Parcel B5

DC/21/90677

Further information requested.

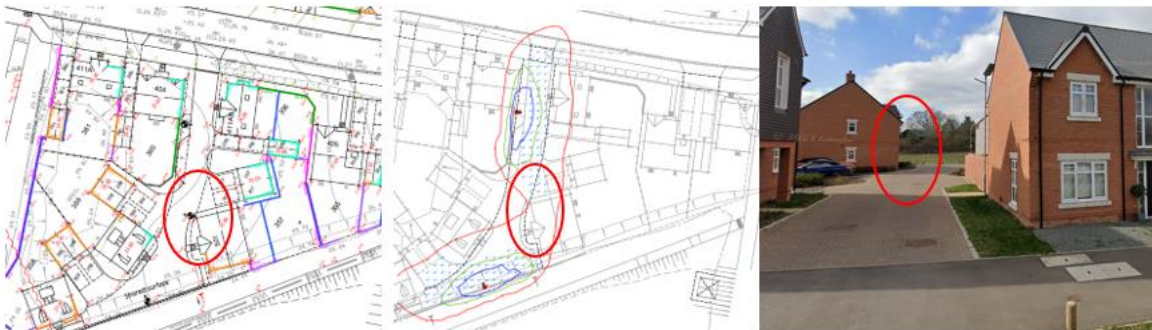
For ease of reference these are the areas I had previously identified were inconsistent:

e.g. lighting column shown outside plot 357 on Engineering Layout but not on Street Lighting Plan rev B or on site.

e.g. 2 lighting columns shown adjacent to plots 336 and 340 on Engineering Layout but only one at end of parking court on Street Lighting Plan rev B and on site.

e.g. 3 lighting columns shown adjacent to plots 347, 348/349 and 350 on Engineering Layout but only 2 shown

adjacent to plots 347 & 350 and in different positions on Street Lighting Plan rev B and on site.

Response:

Please find attached amended plans and lighting layout to reflect the lighting installed on Parcel B5.
